# DS-K1T671 Series MinMoe Terminal Release Notes (2022-03-09)

<b>Device Model:</b> DS-K1T671M/MF	Firmware Version	ARM: ACS_671_AI3_EN_STD_V3.2.0_build220210 ACS_671_AI3_EN_NEU_V3.2.0_build220210
DS-K1T671TMW/TMFW	SDK	Latest version
Naming Rule: M for M1 card, W for WIFI, F for fingerprint	iVMS-4200 Version	Latest baseline

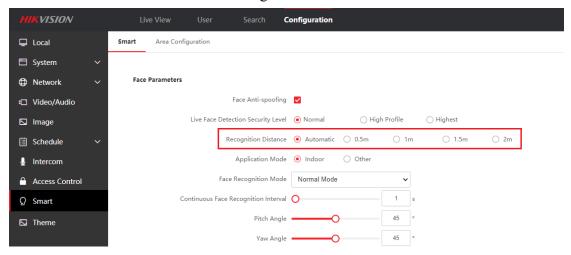
1. Add Hik-Connect menu in device UI Menu→Comm. The function is disabled in default.

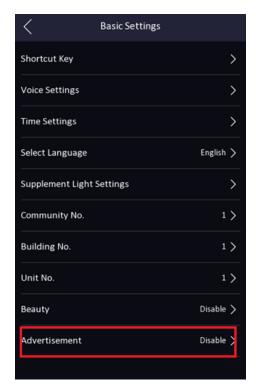
1. Support https feature

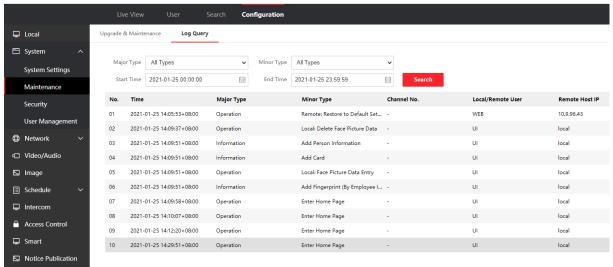
- 2. Support English, Spanish (South American), Arabic, Thai, Indonesian, Russian, Vietnamese, Brazilian Portuguese
- 3. Add Hik-ProConnect platform docking
- 4. Add advertisement mode, after enable, the wallpaper will be fixed to be displayed on the top of main interface.

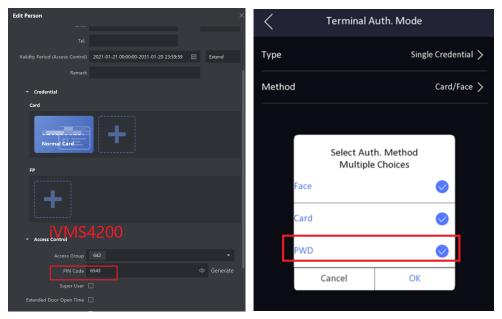
7. Support PIN code to open the door (disabled in default)

Note: PIN code should be configured from software, iVMS4200 already support, HikCentral Pro will support PIN code configuration in V2.1 expected to be released in June

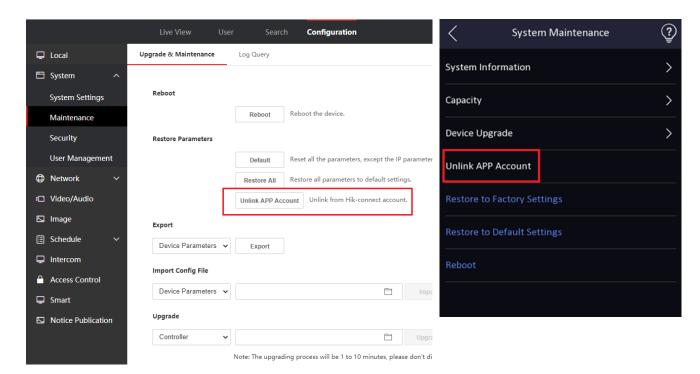
8. Support unbind device with hik-connect account on SADP tool, local UI and web interface

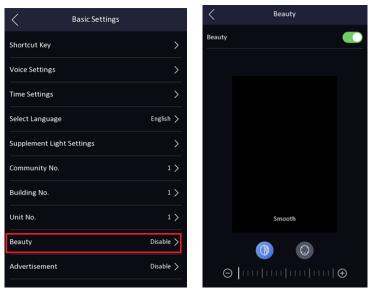
9. Add beauty function to adjust smooth and whiten parameter.

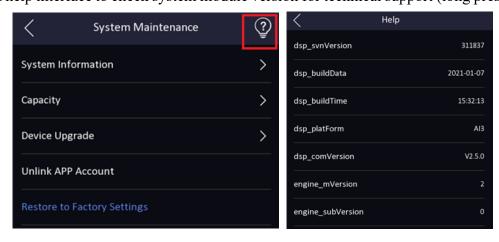
10. Add help interface to check system module version for technical support (long press for 3s).

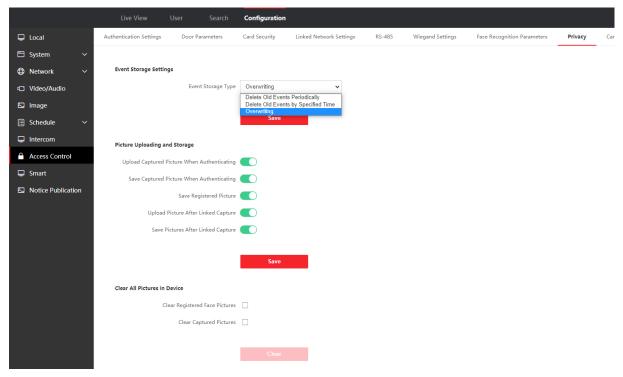
11. Add privacy protection, customer can define the privacy related parameter, such as Event Storage Settings, Picture Uploading and Storage, Clear All Pictures in Device

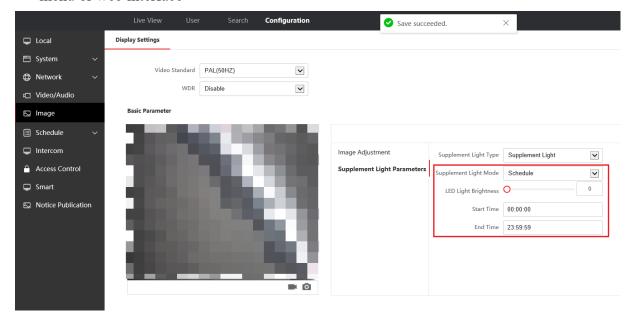
12. Configure the time period when the white light fill light is turned on and off in device local menu or web interface

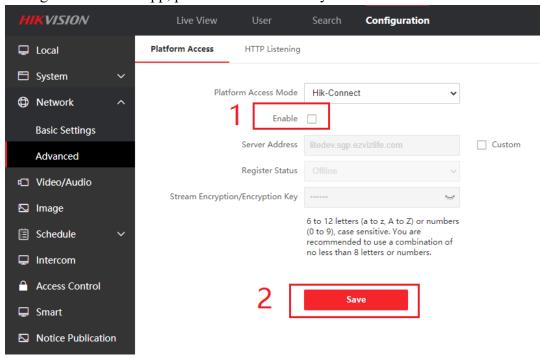
4. Hik-Connect function is turned off in default for privacy protection, if customer want to manage device from App, please turn on manually in the web.

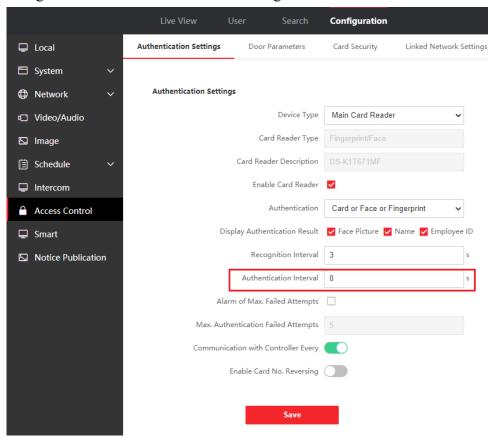
- 5. The face matching algorithm is upgraded. Improve the speed and accuracy of face recognition. Improved the recognition effect of dark masks
- 6. DNS can be configured from device UI in menu→Comm.-->Wired Network

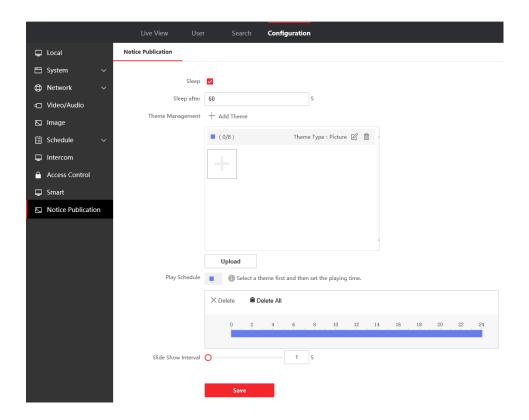
- 7. Optimized the ISUP and Hik-Connect event upload mechanism.
- 8. Add stranger authentication timeout time configuration
